**STAFF REPORT: 5/11/2022 MEETING**

**APPLICATION NUMBER: #22-7807**

**ADDRESS: 1053 BURNS**

**SCOPE: ENCLOSE REAR PORCH**

Figure 5 Birds-eye view of new door, wells, and widened staircase

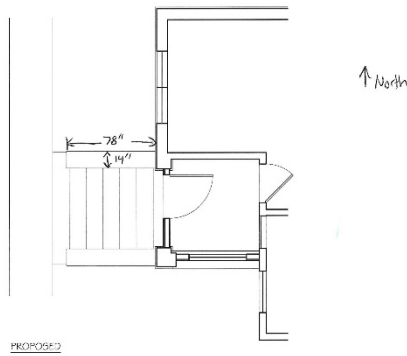
- While staff understands the proposal's attempt to match the existing dimensions of the nearby sunporch steps and wingwalls, it is staff's opinion that some of these dimensions exceed relative dimensions to the porch itself: the width of the steps and the position of the interior side of the proposed wingwalls goes outside the plane of the interior porch walls (see proposed elevations 1-3), there appears to be an addition of 2 steps (2 risers) in the proposed stairs that may not be required because both the landscape and the porch heights may be at different elevations, and the length and scale of the wall seems to be disproportionately larger than necessary in relation to this smaller porch. In summary, the dimensions of this wall and stair should be localized to the historic scale of this smaller porch, in staff's opinion, rather than attempting to match the dimensions of the sunporch.

- Staff offers the opinion the proposed width of the stair shall not exceed the width of the existing interior space between the pier and the exterior wall, that the height of the wingwall not exceed the height of the porch, except for the limestone cap.
- Staff has no issue with the proposed replacement of the brick steps with limestone steps.

- The applicant provide drawings to HDC staff for review and approval that show the proposed width of the stair shall not exceed the width of the existing interior space between the pillar and the exterior wall, that the height of the wingwall not exceed the height of the porch, except for the limestone cap.

Figure 3 Back Porch with new door, siding and enlarged staircase

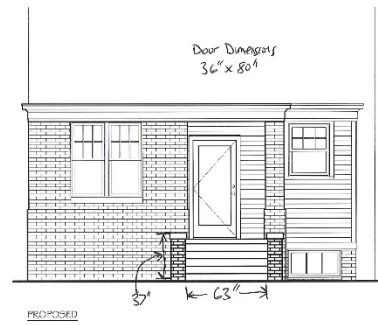
- Staff observed that the proposed door location is not centered in the proposed enclosed west wall, nor to the steps, and would not match the symmetry of the centrally located sunporch door in relation to its steps.

- Staff offers the opinion that covering or the removal of the existing siding, door, icebox entrance, and the enclosure of the porch with a solid wall obstructs or alters these historic character-defining features that connects this porch with other historic porches of this house and therefore is not appropriate, because it destroys the historic character of the property (Standards 2 and 3), removes distinctive features (Standard 5), does not match the character-defining feature of the original porches in design, texture, and other visual properties (Standard 6).
- While the proposed porch enclosure with a solid wall is not appropriate, staff offers the opinion that, leaving all exterior features in place, the use of windows that matches in material and design to the

sunporch, with its centralized door placement, would be an appropriate use that is not in conflict with the house's historic architecture.
